Executive Summary Conditional Use / Residential Demolition

Date: January 28, 2016
Case No.: 2013.1213CUA
Project Address: 313-323 Cumberland Street
Permit Application: 2014.0627.9813 and 2014.0627.9820
Zoning: RH-1 (Residential - House, One-Family)
40-X Height and Bulk District
Block/Lot: 3601/043-044
Project Sponsor: Tuija Catalano
Reuben, Junius & Rose, LLP
One Bush Street, Suite 600
San Francisco, CA 94104
Staff Contact: Erika Jackson – (415) 558-6363
erika.jackson@sfgov.org
Recommendation: **Approval with Conditions**

Planning Commission Draft Motion

EXHIBIT C

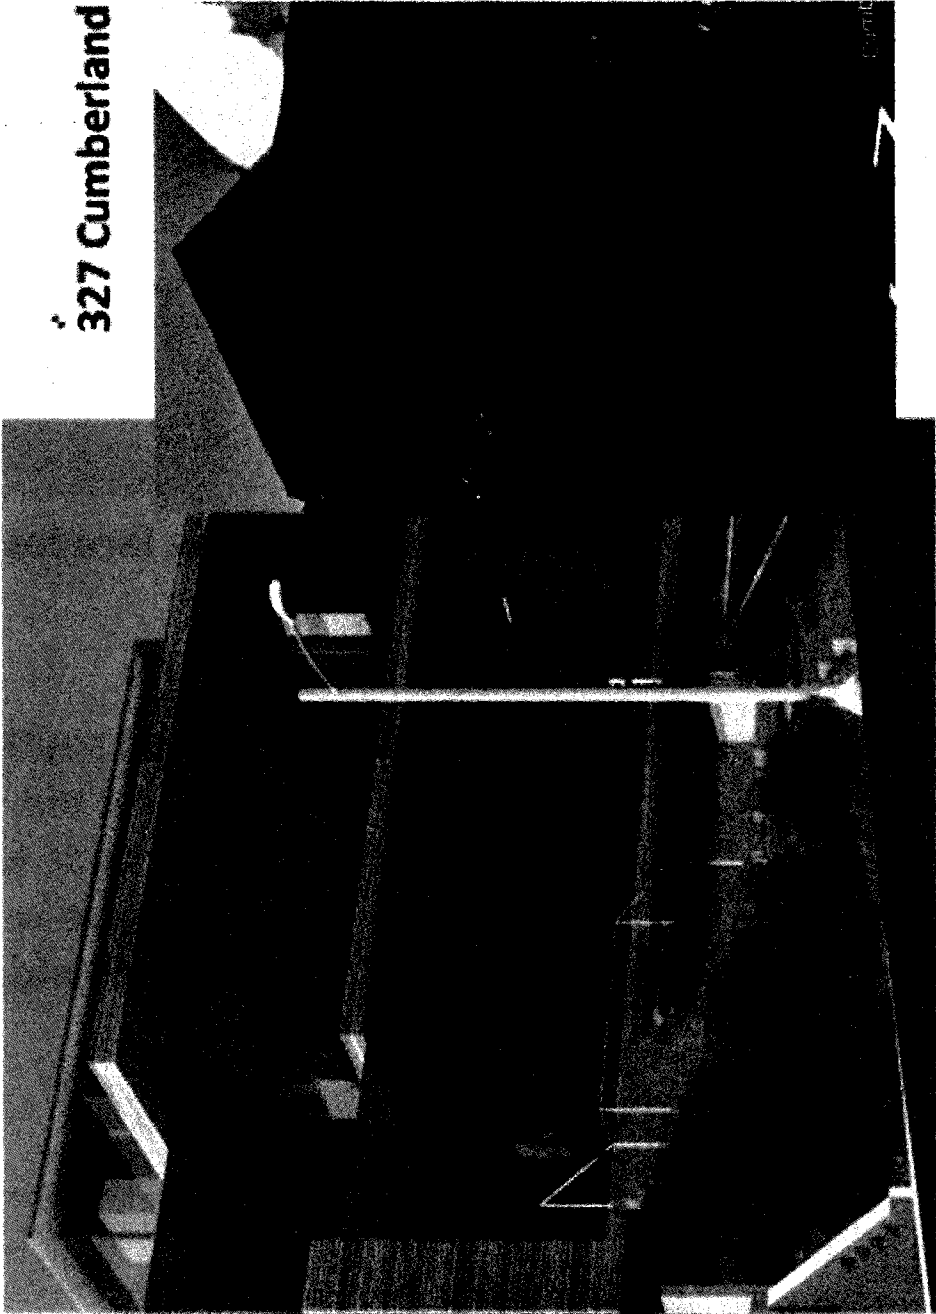
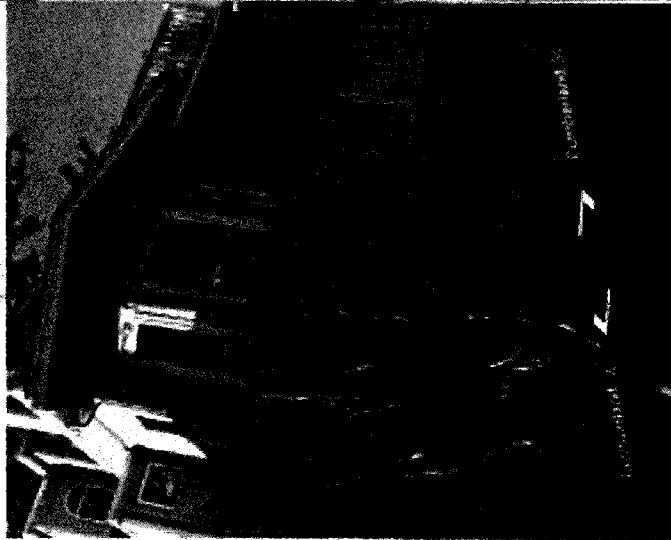
Lot is 33 feet wide by 30 feet deep. Facade is broken up and stepped in two pieces to reduce visual impact.

Proposed merged lot is 50 feet wide by 114 feet deep. Facade is barely articulated and fails to relate in any way (scale, materials, massing, details, or fenestration pattern) to immediately adjacent neighbors or most other buildings on the block.

EXHIBIT D

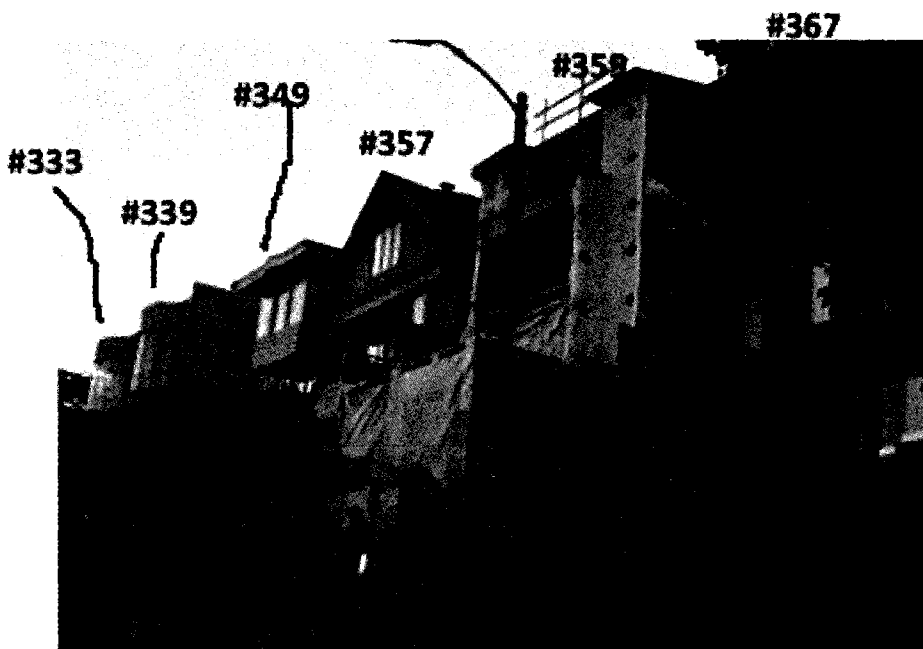
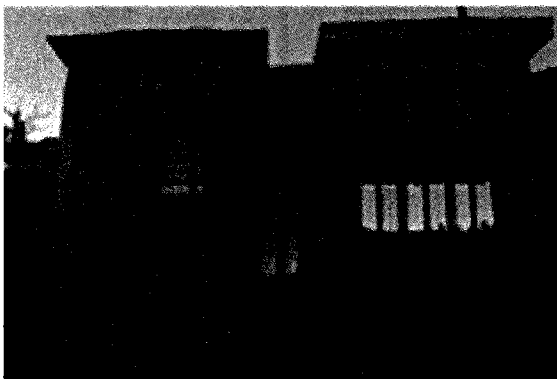
Typical building scale across the street: 25-wide facades on 25-foot wide lots.

Taller on south side of the street but still either 25-foot wide lots and buildings or reading as 25-foot wide.

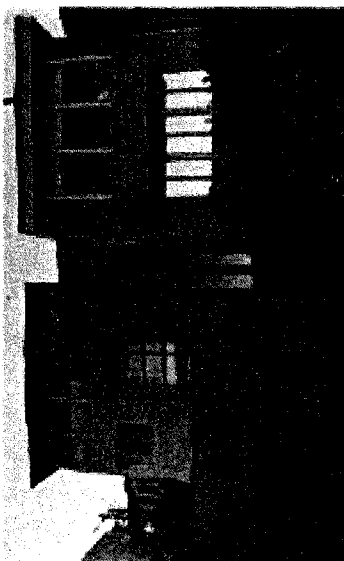
There are only two lots on this block that are 50 feet wide -- lot 38 and lot 45. Homes on both these lots are under 2300 sf each and are broken up into two discrete frontages to read like two separate buildings.

Home on lot 45 -- also broken into parts

Lot 38 home broken into two parts
